UNITED STATES PATENT AND TRADEMARK OFFICE

APPLICATION NO.	FILING DATE	FIRST NAMED INVENTOR	ATTORNEY DOCKET NO.	CONFIRMATION NO.
10/803,282	03/18/2004	Scott A. Wojan	WOJ-100-A	5647

Office Action Summary

DETAILED ACTION

Chapman attachment # 1
(10803282, 03/24/05)

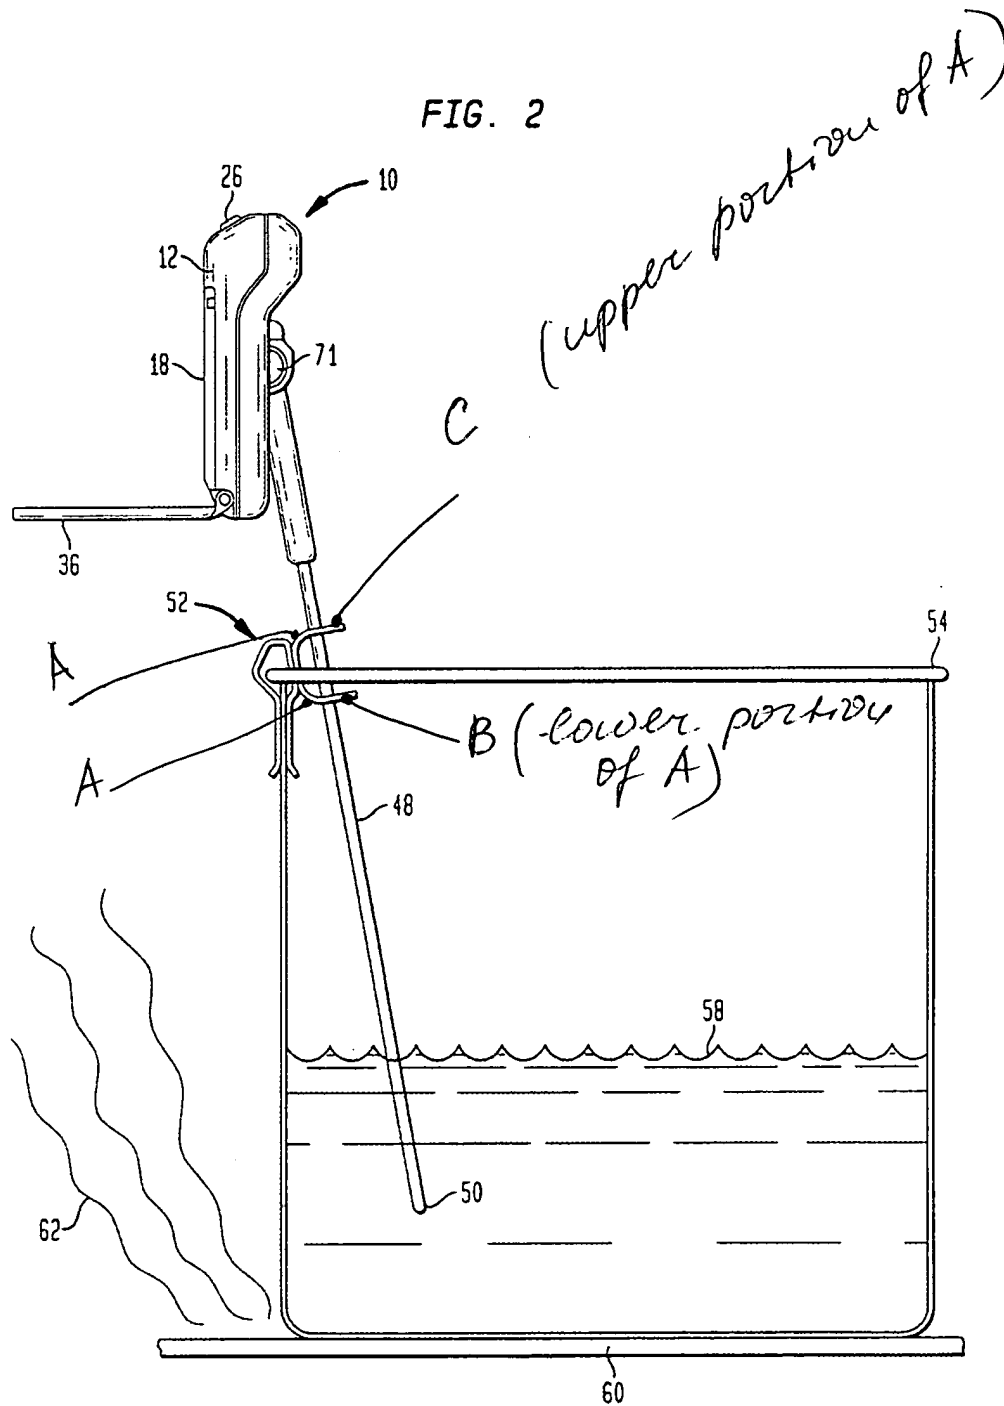
Chapman discloses a device in the field of applicant's endeavor comprising all the limitations of claim 31, including a housing 10, a control device (circuit) within the housing, a temperature probe 48, a display 18, an audible (visual message/identifier) device operably connected to the control device (circuit), and a support member 52 having a substantially planar radially extending outward from the probe portion A having a lower portion B positioned away from a housing 10, and an upper portion C positioned closer to the housing 10. The support member is engageable with a rim of a vessel, as shown in Fig. 2. (The numerals A-C have been added by the Examiner, see attachment # 1 to the Office action).

attachment # 2
(10803 282, 03/21/05)

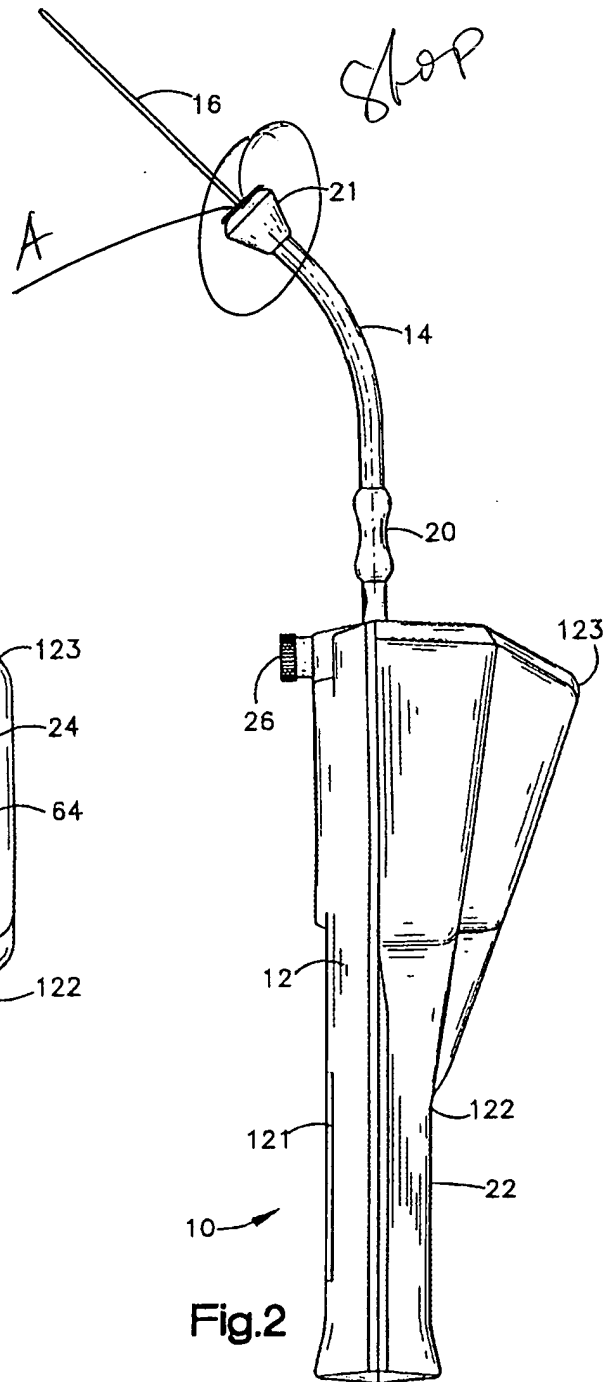
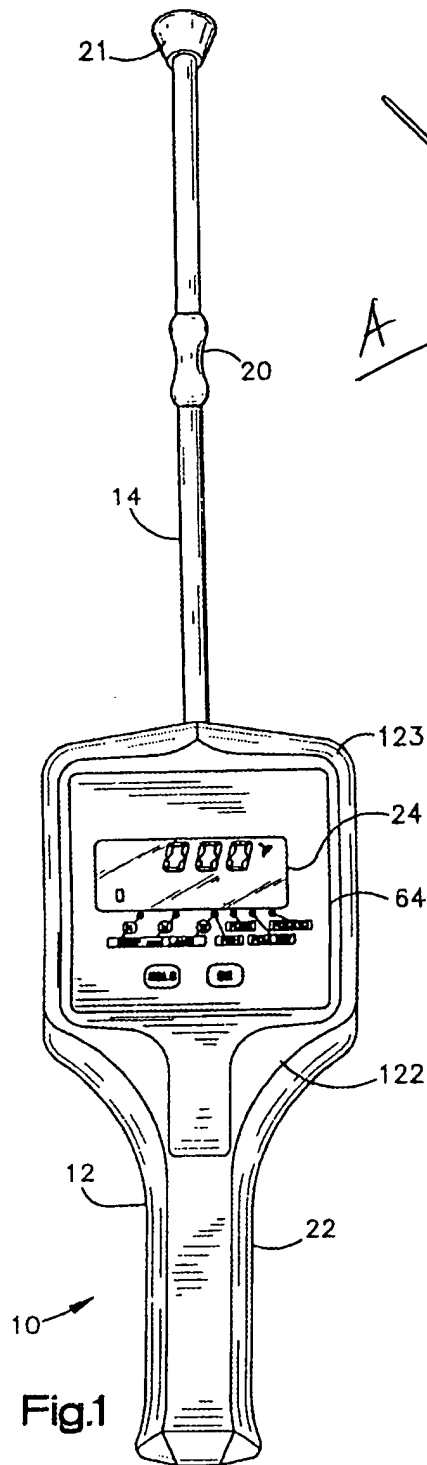
The device comprises a support member 21 attached to the temperature probe containing the infrared temperature sensor, the support member 21 having substantially planar portion A extending outward radially, as shown in Fig. 2. The support member 21 substantially coincides with the longitudinal axis of the temperature probe 14.

(The numeral A has been added by the Examiner, see attachment # 2 to the Office action).

attachment #3
(10803282, 03/21/05)

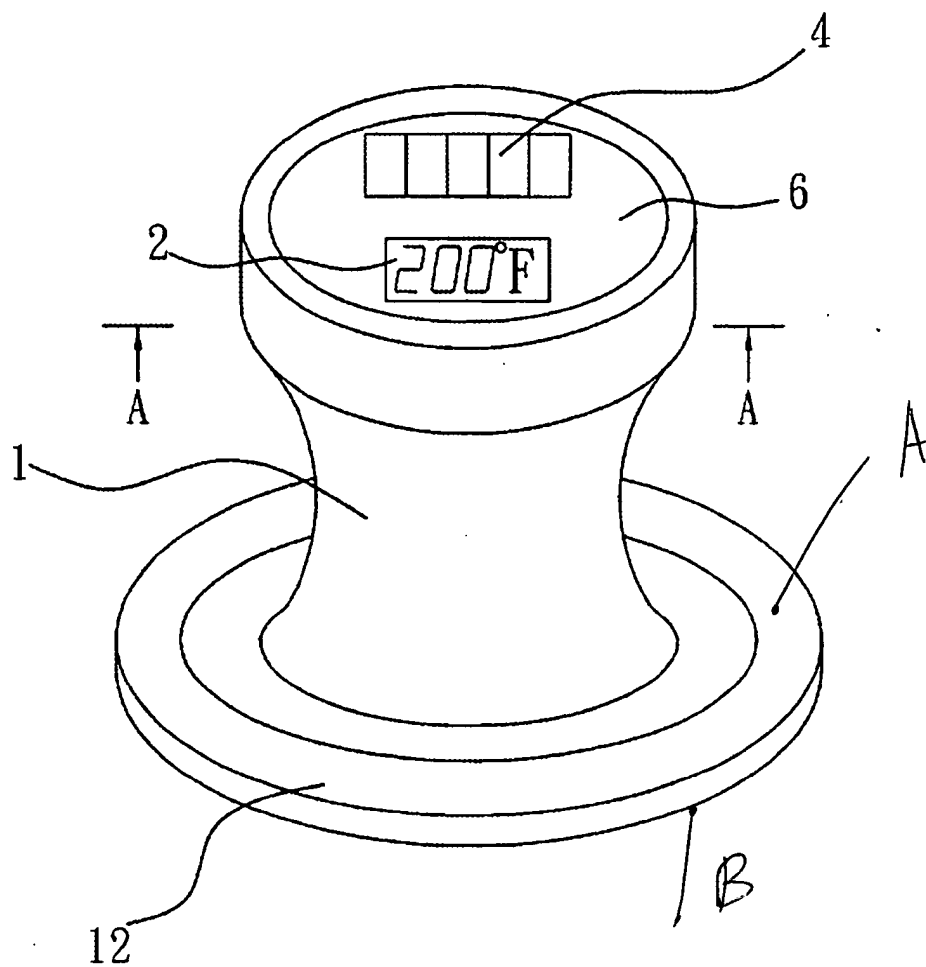
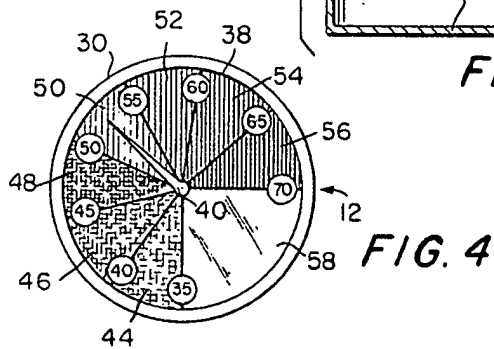
For claim 9: the substantially planar portion 12 of the support member 1 has an upper surface A positioned toward a housing (including display 6), and a lower surface B comprising a portion 131 positioned away from the housing, the lower portion B is engageable with a surface where the food of interest is.

(The numerals A-B have been added by the Examiner, see attachment # 3 to the Office action).

Hofer attachment # 4
(10803282, 103/21/05)

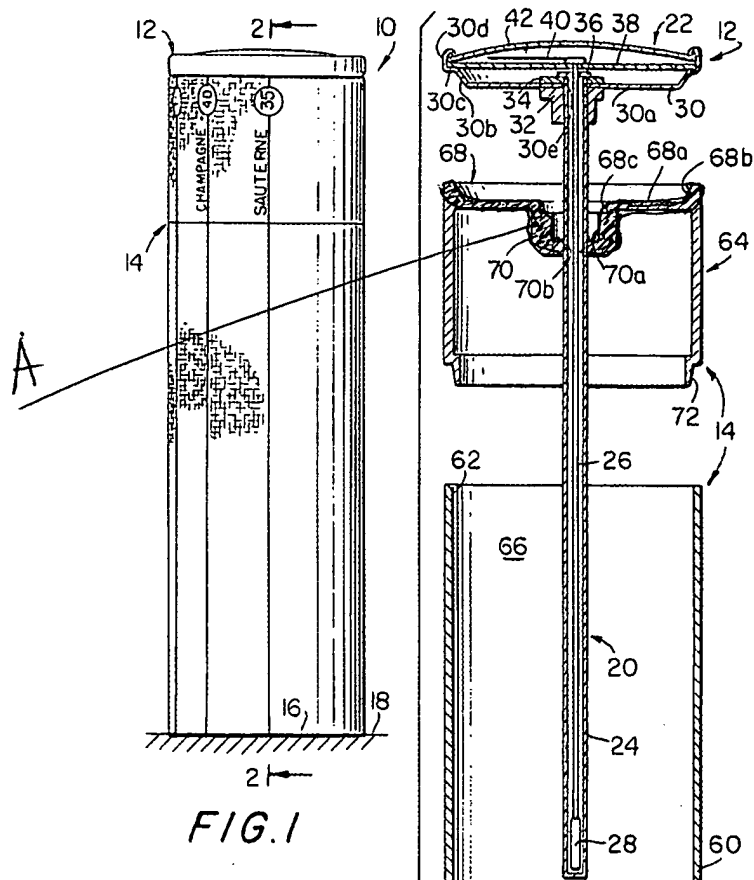
For claim 10: the support member 64 has portion A which has a substantially arcuate shape forming a concave upper surface and a convex lower surface, as shown in Fig. 2, and in the attachment # 4 to the Office action.

For claim 12: the longitudinal (vertical) axis of the infrared temperature sensor 20 intersects a centroid (central opening) B of the support member 64.

For claim 13: the support member 64 has a substantially disk-shaped portion C.

(The numeral A has been added by the Examiner, see attachment # 4 to the Office action).
